North Transfer Station Stakeholder Group Compendium

Chapter 4: Workshop 1

Workshop 1: Sept. 14, 2010

North Transfer Station
Stakeholder Workshop #1 Summary
Sept. 14, 2010
Institute for Systems Biology • 5 to 8 PM

CONCEPT 1 BASE SCENARIO

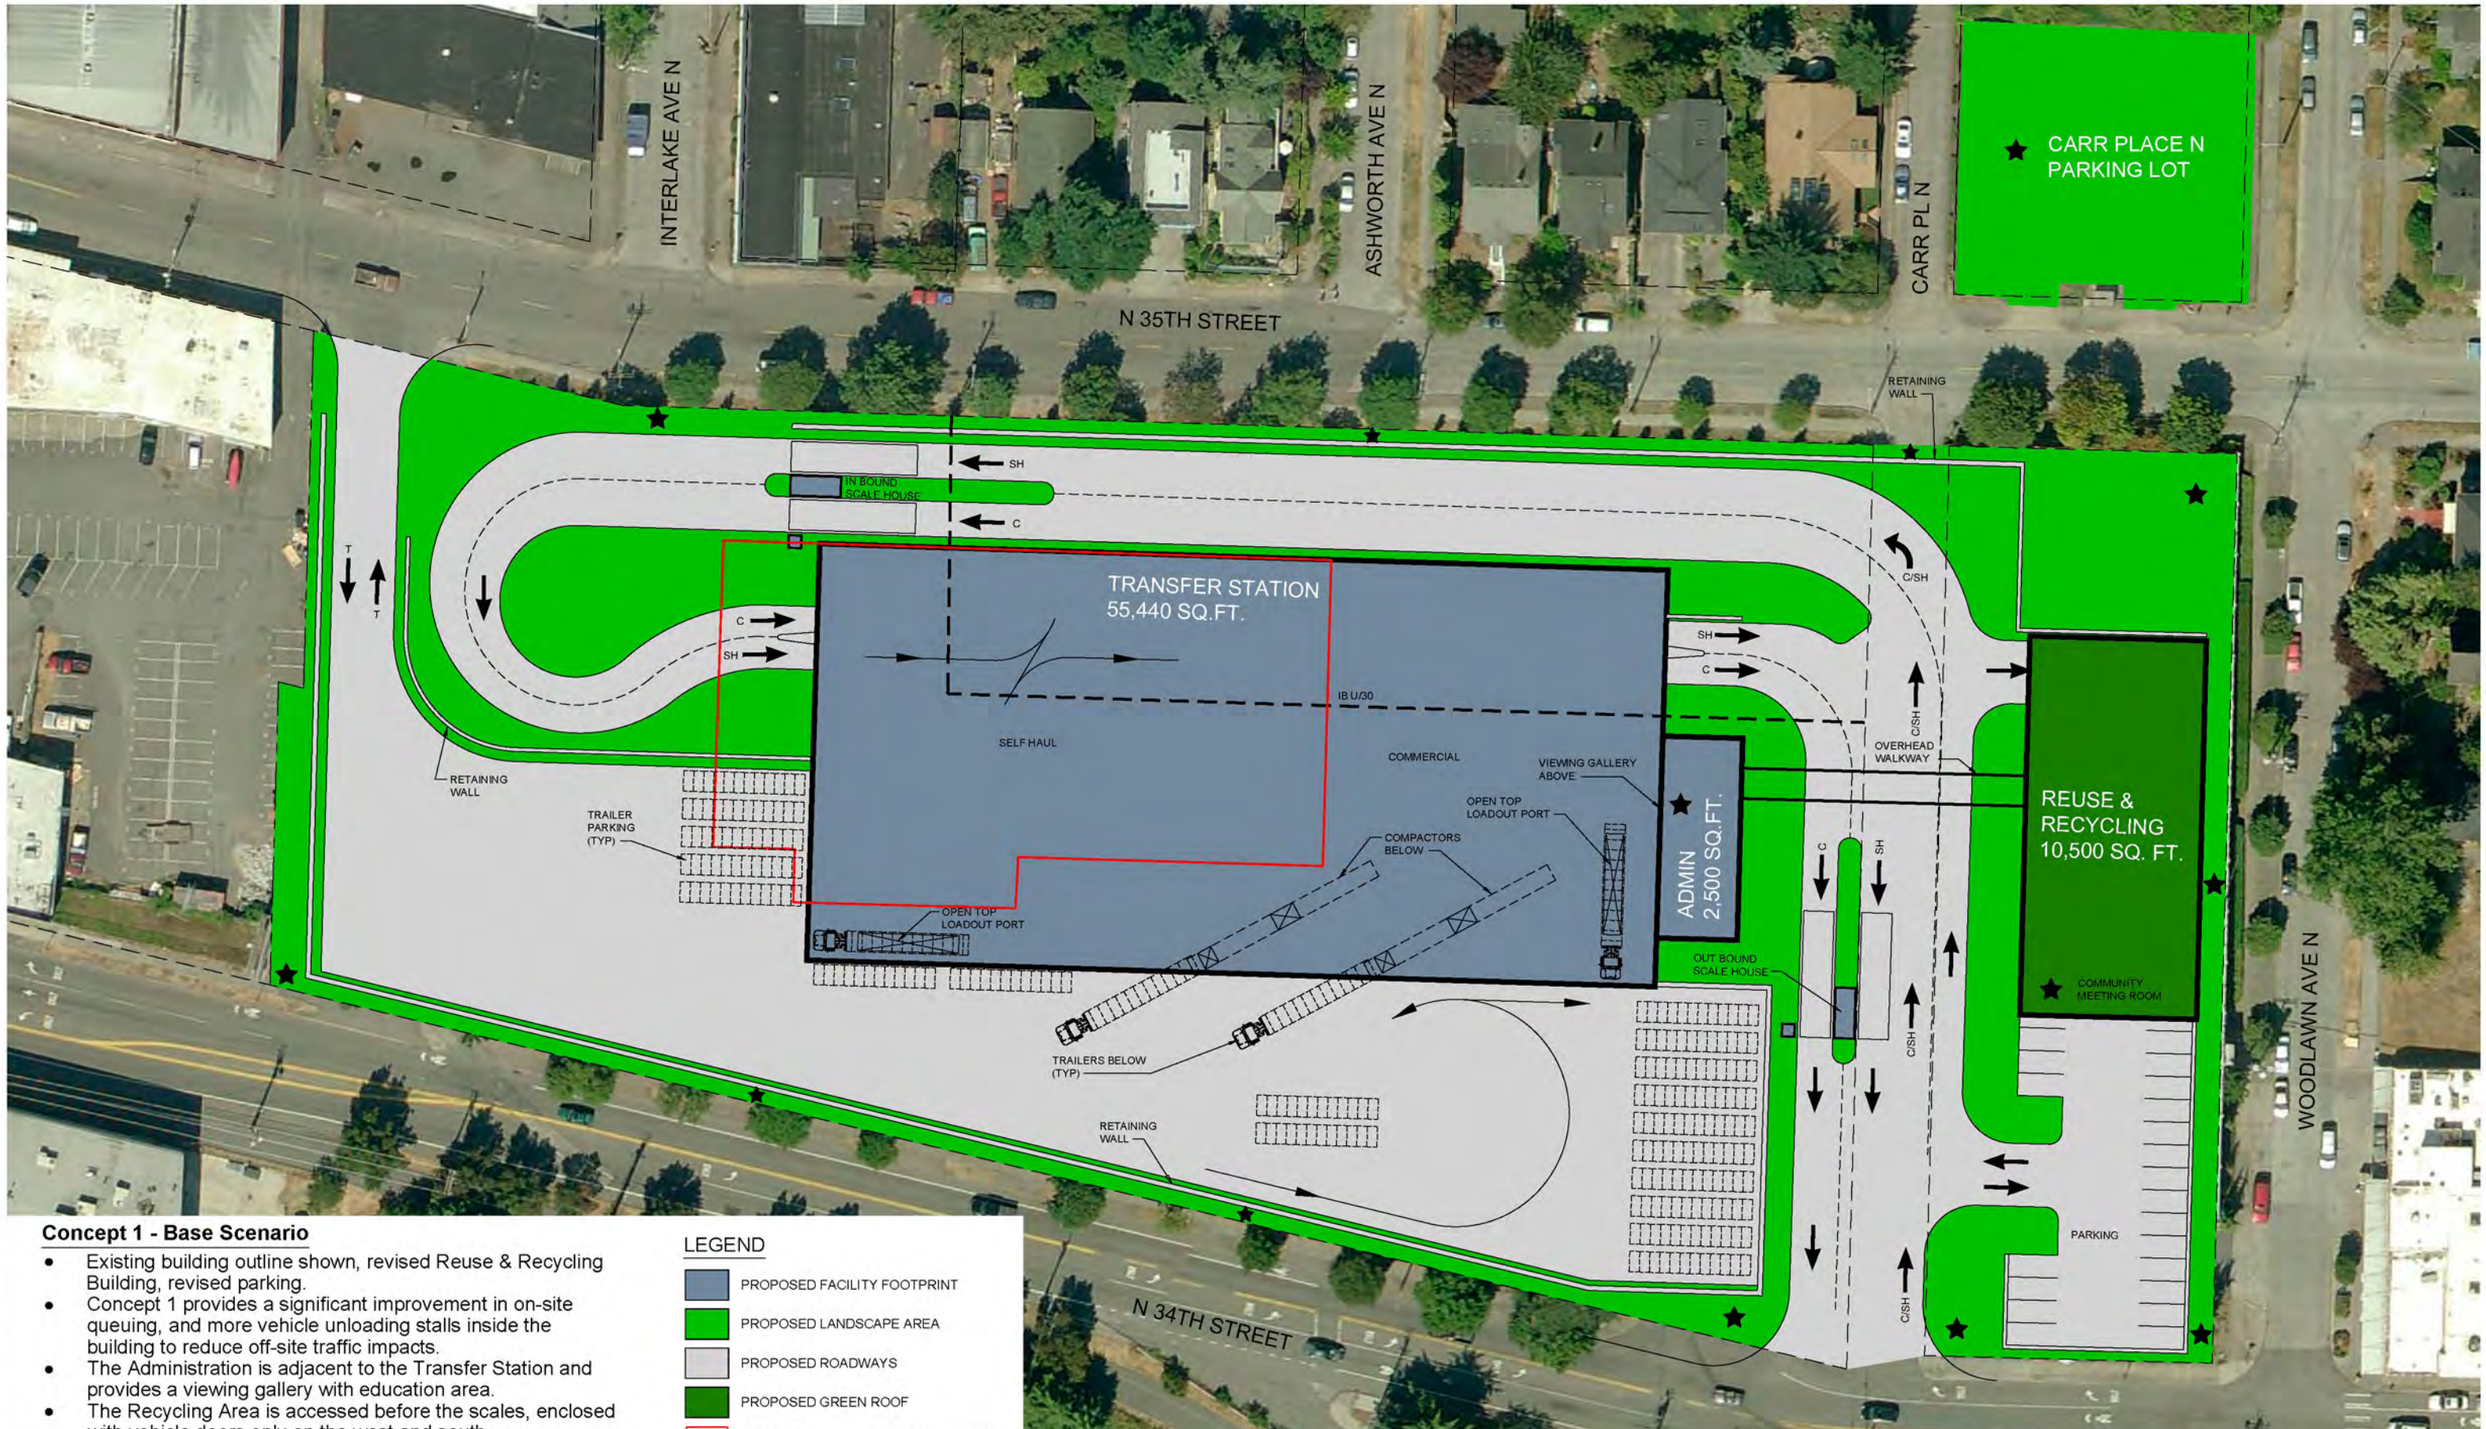
Concept 1 - Base

- (S) Parking lot in the northeast corner could open neighborhood to increased noise.
- (S) Why not add more parking to south side of building?
- (S) Exit from transfer station too close to the northeast corner for doors that will always be open – noise, smell.
- (O) What types of community amenity do you envision on a small strip of land between N. 34th Street and where trucks are hauling trash?

CONCEPT 2
MAXIMUM SCENARIO

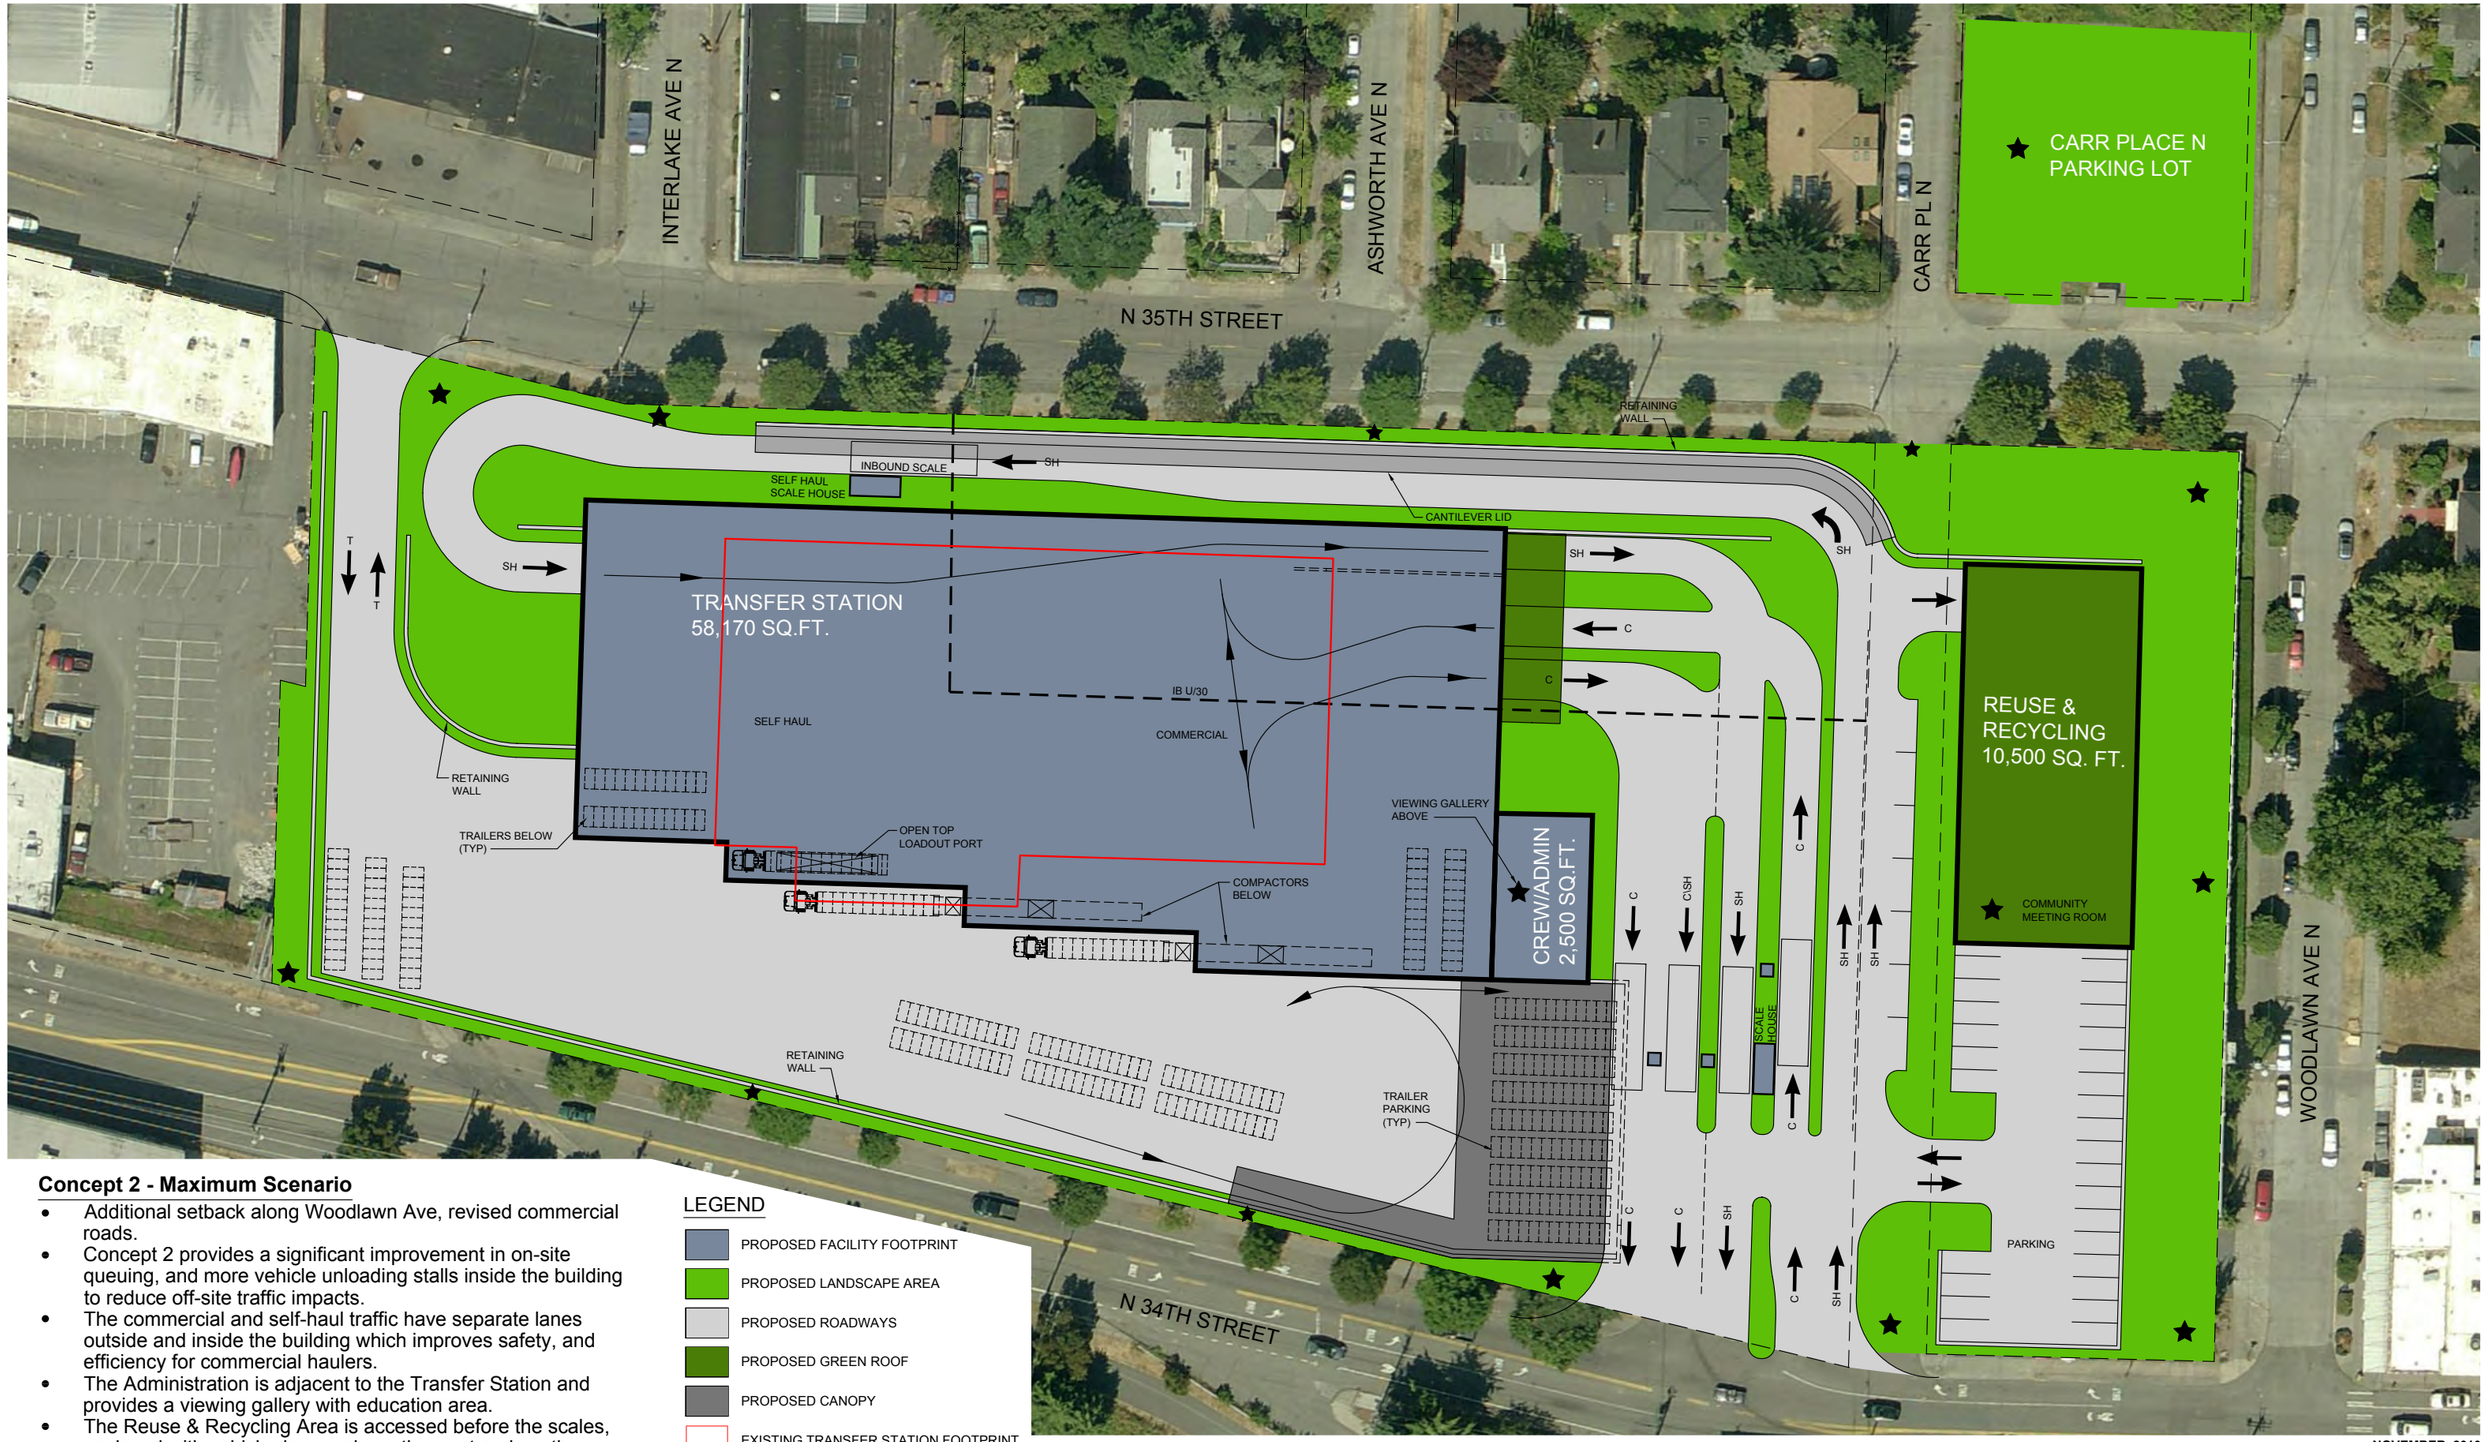
Concept 2 - Maximum

- (S) Too much roadway.
- (S) There is a big turning radius in concept 1 as you enter the building but a much smaller one in concept 2. Why is there a need for so much space in concept 1?
- (S) What would extra space be used for within the station?
- (S) If buffer here [on N. 34th Street] was 20 ft instead of 10 ft we could have real retail.
- (S) I like to separate commercial from self haul (completely).
- (S) Transponders on trucks for regular visits by self haulers with dump truck capability.
- (O) There is not enough buffer at Woodlawn Avenue, remove parking at the northeast corner, develop truck entry at N. 34th Street – move all west.
- (O) This parcel (Interlake Avenue and N. 35th Street) should become a community center/community amenity, in exchange for street vacation.

CONCEPT 3
NO REZONE
NO STREET VACATION

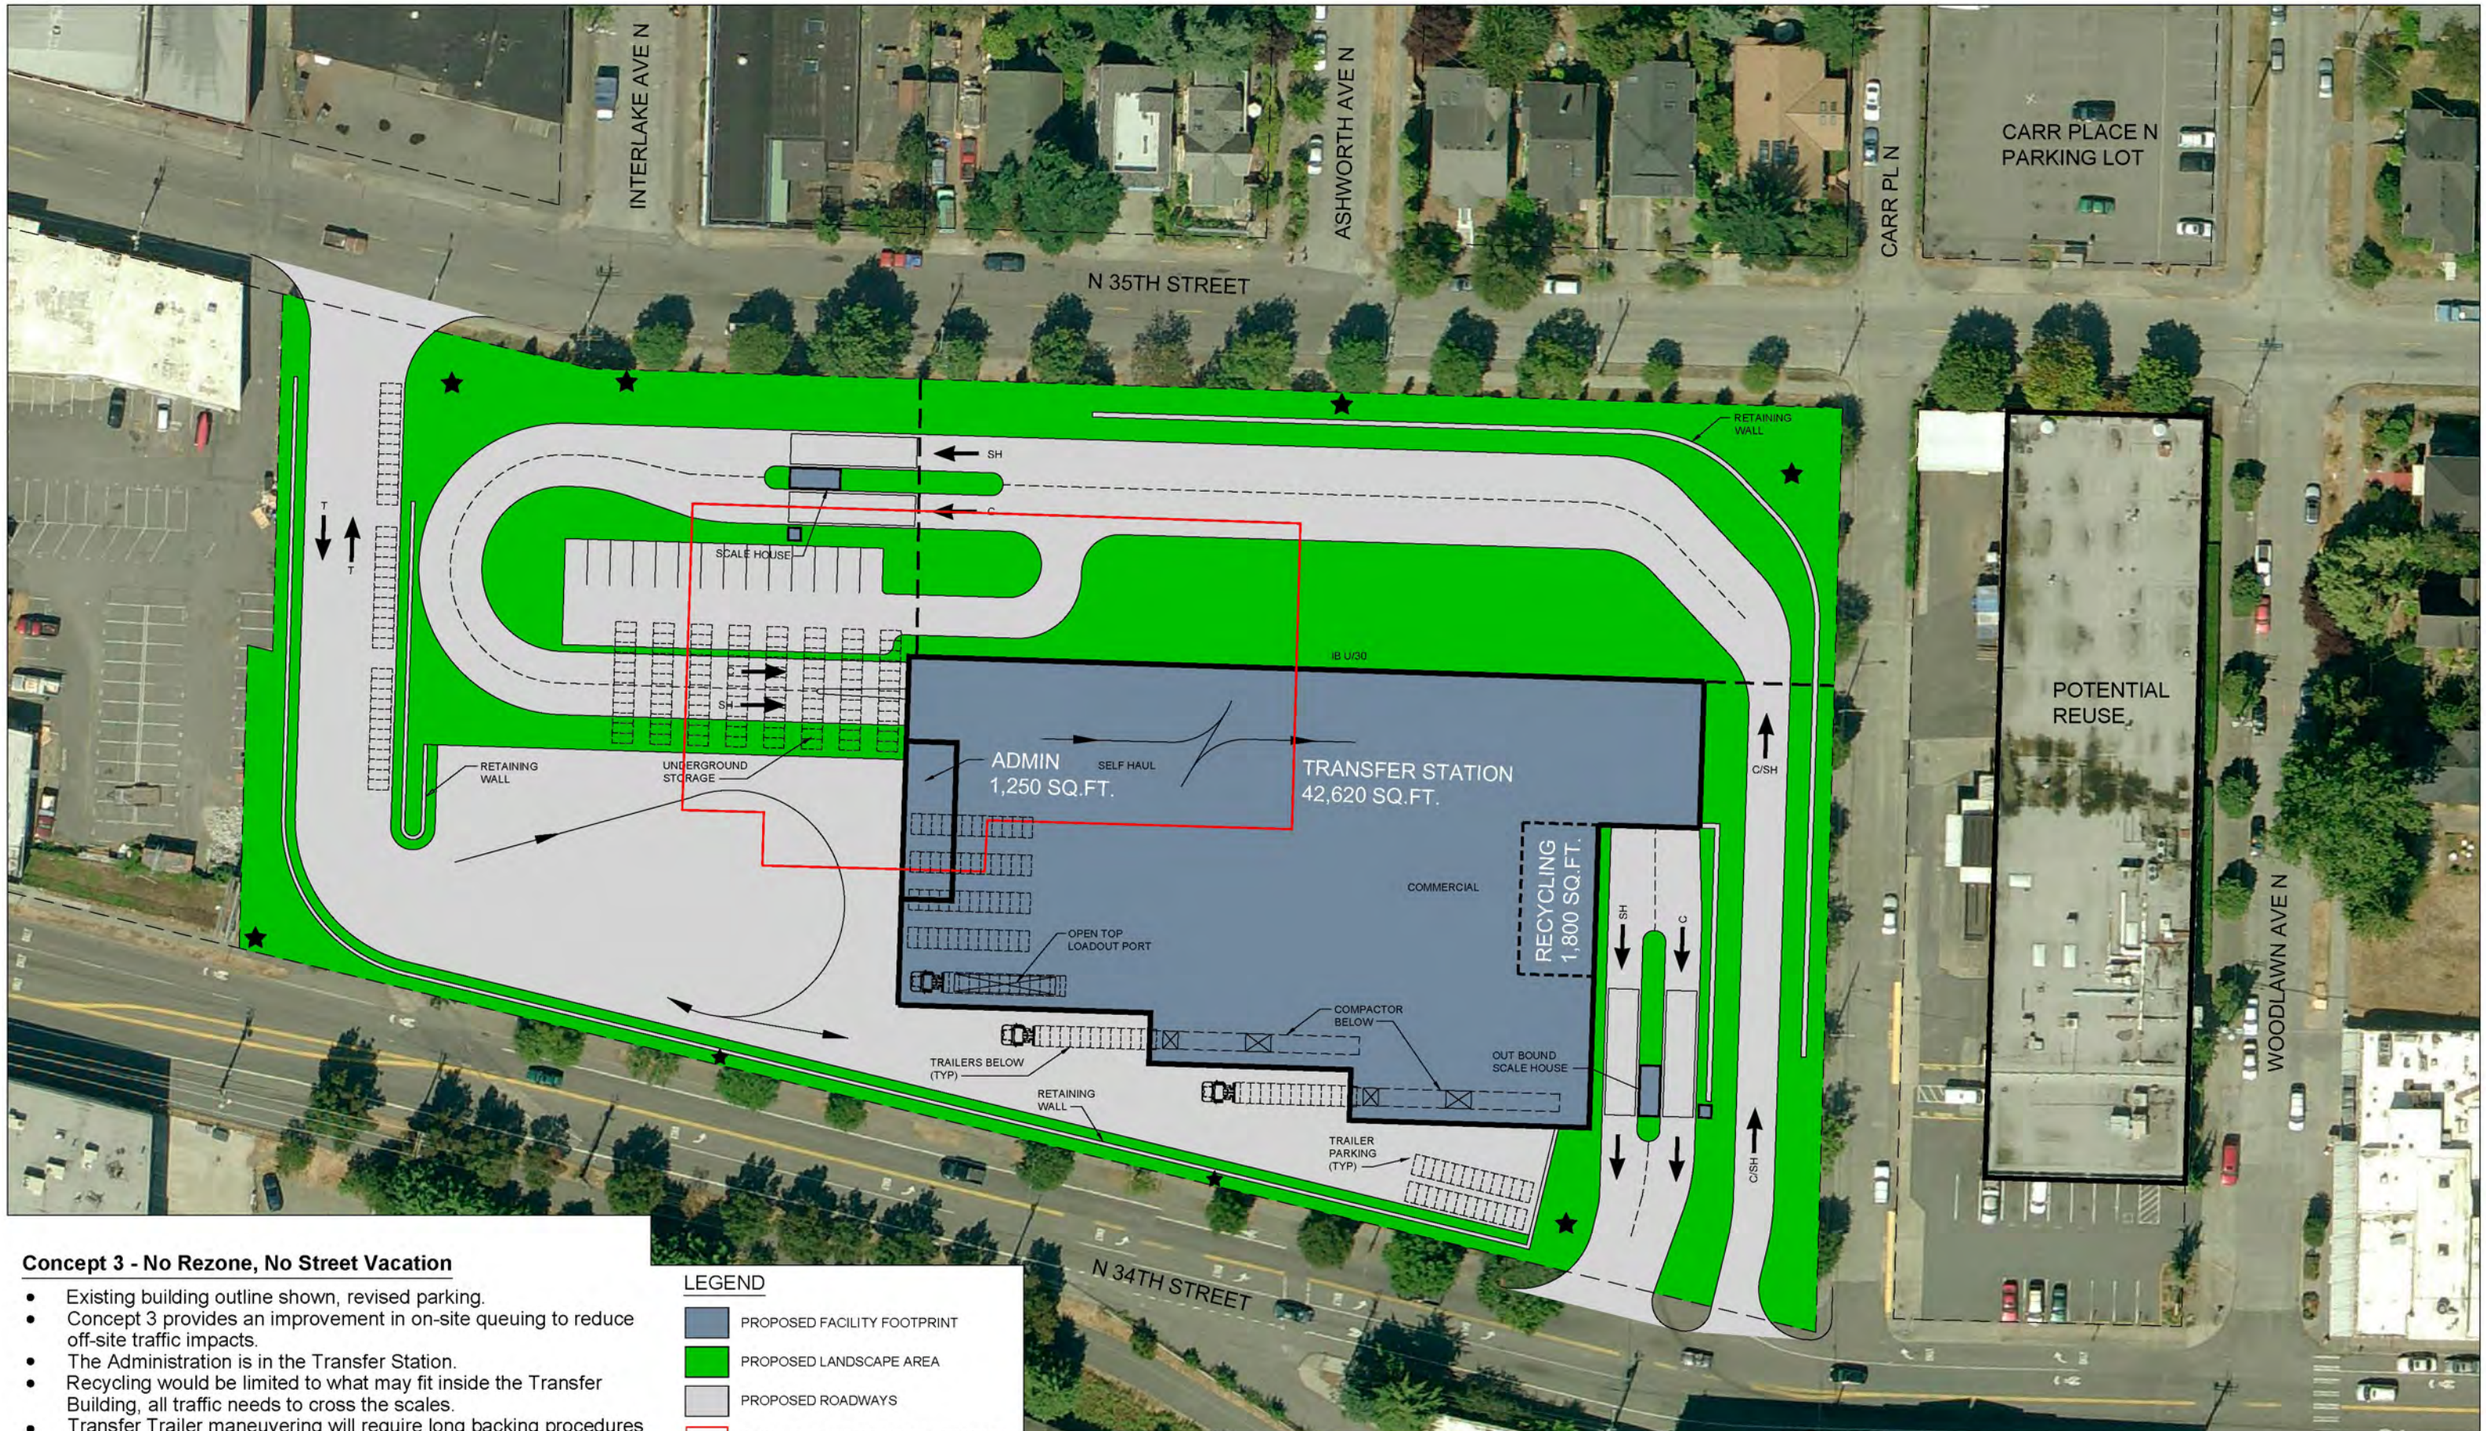
Concept 3 - No Rezone/No Street Vacation

- (S) Why not move transfer building farther west?
- (S) If Carr Place is closed, what other options might be considered?
- (S) Can all vehicles use one entrance? Delete the entrance at N. 35th Street and make one route for all off N. 34th Street, including large trucks. Consider vacating Carr Place but keep recycling on [the transfer station] site.
- (S) Why couldn't there be a viewing gallery on this site? There's one in Concept 6 and it's a smaller building.
- (O) Concern regarding the [1550] building that will probably be sold to developers – this will probably worsen the parking and traffic problems. Parking is already terrible for homeowners.

(O) Why can't you or haven't you explored a concept that does not rezone 1550 but allows a better design of the facility? The presentation implied that the no rezone gave the least useful facility.
(O) Look at only taking over Carr Place and add a park to Carr Place parking.
(O) Look at Allison's scheme.
(O) Too much back up.
